Product Change Notification / RMES-16SJKO622

CCB 4550 and 4550.001 Final Notice: Qualification of STAR as an additional assembly site for selected Micrel products available in 4L VDFN (3.2x2.5x0.9mm) and (2.0x2.5x0.9mm) packages.

PCN #: RMES-16SJKO622

LEAD FRAME COMPARISON

NSEB

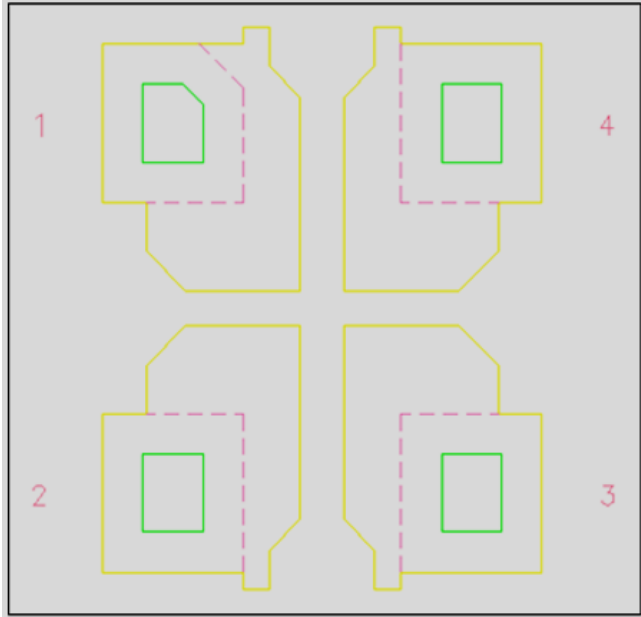
Leadframe Material	A194
Lead Lock (Locking Hole)	No
Lead Plating	NiPdAu

STAR

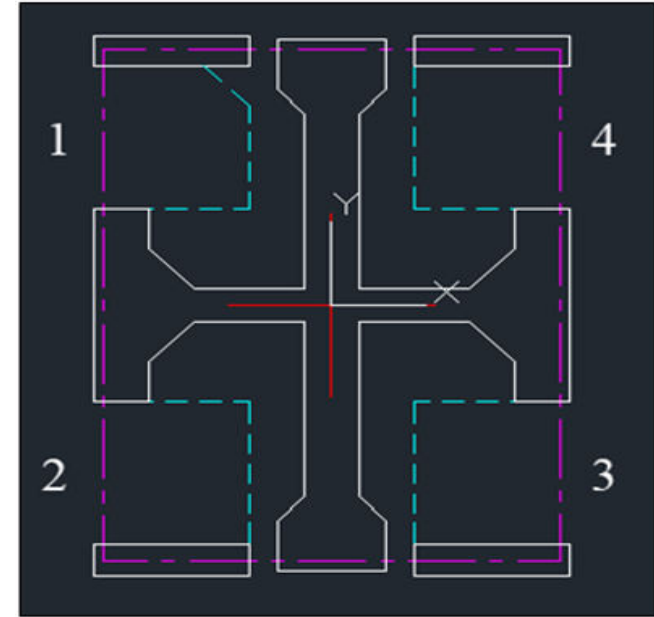
Leadframe Material	A194
Lead Lock (Locking Hole)	No
Lead Plating	NiPdAu
